## PRODUCT/PROCESS CHANGE NOTICE (PCN)

### ATTACHMENT I - PCN # : A1911-01

This notification is to advise our customers that IDT is adding 2D barcode on the product marking to improve traceability. The 2D barcode contains wafer and substrate information.

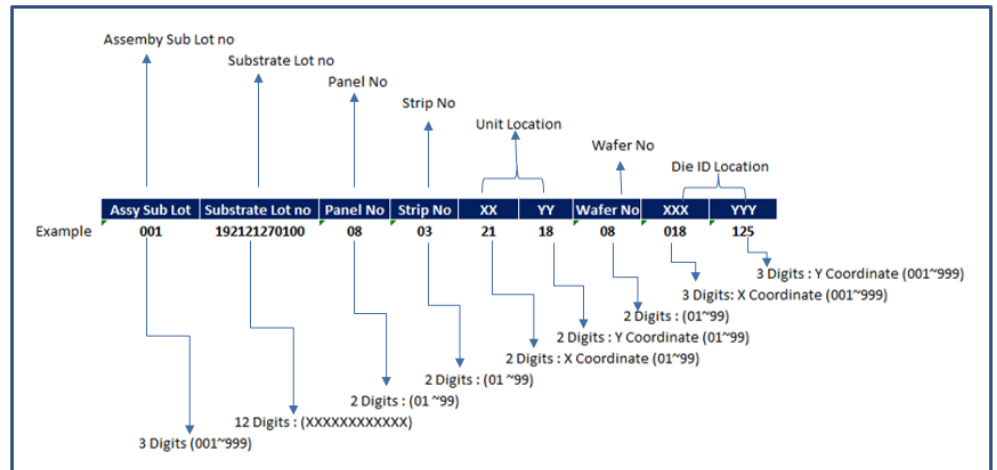
RCD: 13.5 x 8.0 mm

DB: 7.5 x 3.0 mm

## DDR4 RCD Marking Format and Dimension

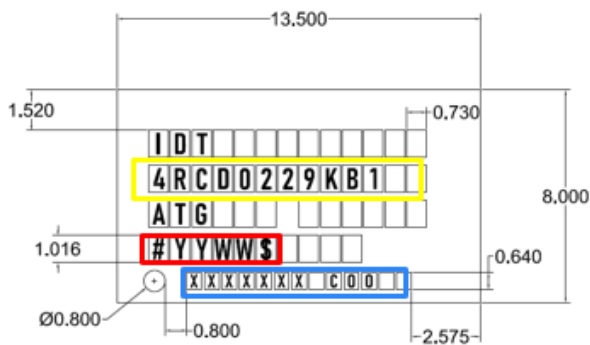
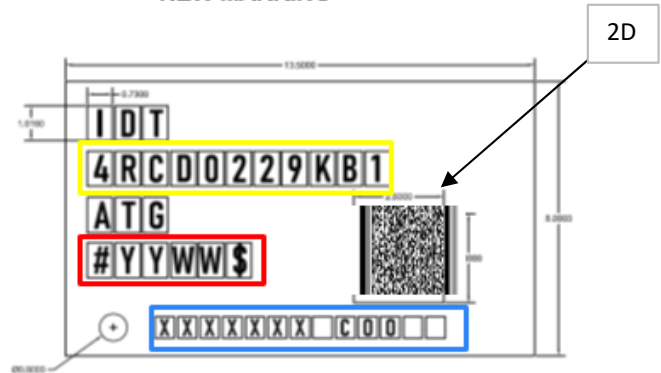
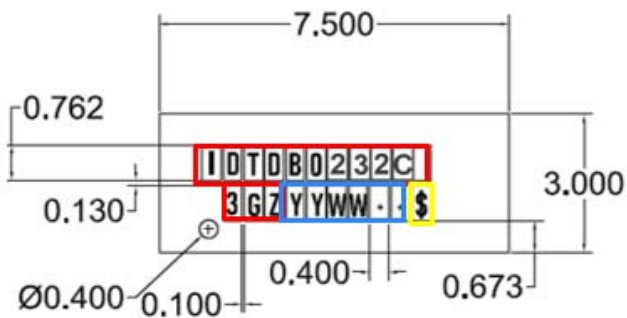
- Fixed Substrate level 2D ID Content
  - 17 digit max
  - Lot no (12) + PP + SS
- Combine Sublot + Substrate 2D ID info + Unit code + wafer and die ID and mark into IDT Unit
  - Total 31 digits
  - Assembly Sublot (3)
  - substrate Lot no (12)
  - Panel No PP(2)
  - Strip No SS(2)
  - Unit Location , XXY(4)
  - Wafer ID WW(2)
  - Die Location XXXYYY (6)

## DDR4 DB Marking Format and Dimension

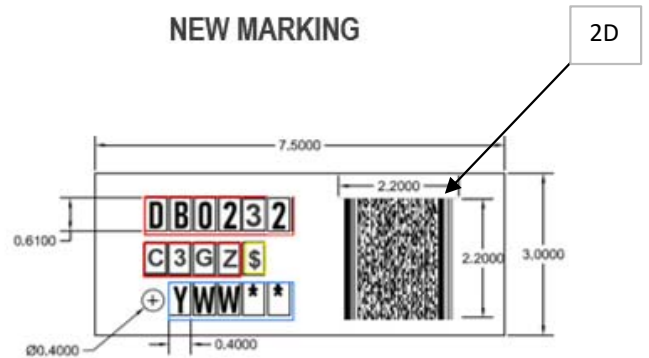
- Fixed Substrate level 2D ID Content
  - 17 digit max
  - Lot no (12) + PP + SS
- Combine Sublot + Substrate 2D ID info + Unit code + wafer and die ID and mark into IDT Unit
  - Total 31 digits
  - Assembly Sublot (3)
  - substrate Lot no (12)
  - Panel No PP(2)
  - Strip No SS(2)
  - Unit Location, XXYY(4)
  - Wafer ID WW(2)
  - Die Location XXXYYY (6)
